# Access Compliance Report

## Public Rights-of-Way

| Intersection ID: N/A                    | Main Street: SUMMERFIELD RIDGE LN | Cross Street: LITTLE STREAM DR          | Location: NW           |
| ADA ID: D6422FAE9928                    | Ramp Type: BlendTrans1            | Initial Pass/Fail: Pass                 | Overall Compliance: No |

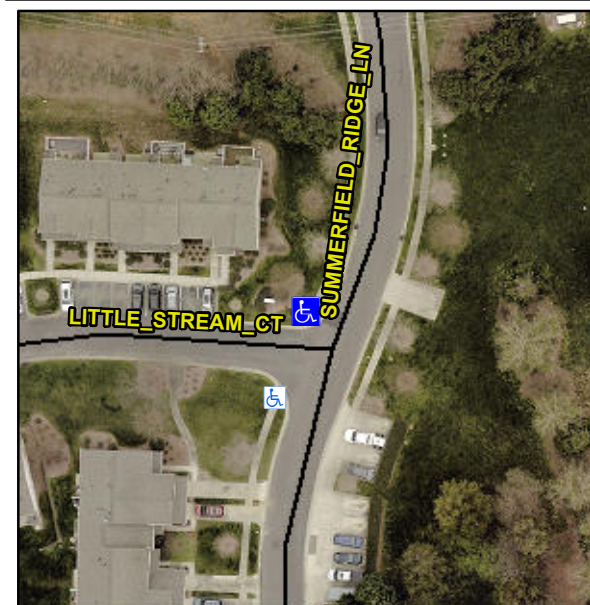
**DAMAGED GTR**

**R304.2.1, R304.2.2-Perp, R304.3.2-Para, R305.1.4, R305.2, R304.5.4, R304.5.3**

| Compliance | Description           | Data   | Compliance | Description                 | Data   |
|------------|-----------------------|--------|------------|-----------------------------|--------|
| No         | Landing Length (in)   | 47.0   | Yes        | DWS Provided?               | Yes    |
| No         | Landing Slope (%)     | 2.7    | Yes        | DWS Length (in)             | 24.0   |
| Yes        | Landing X Slope (%)   | 0.6    | No         | DWS Full Width?             | No     |
| Yes        | Gutter Ponding?       | No     | No         | Gutter Slope (%)            | 9.9    |
| Yes        | Gutter Lip Ht (in)    | 0.0    | No         | Gutter X Slope (%)          | 2.1    |

**Remove & Replace Curb Ramp With Two New Directional Ramps or Equivalent. Remove & Replace Gutter.**
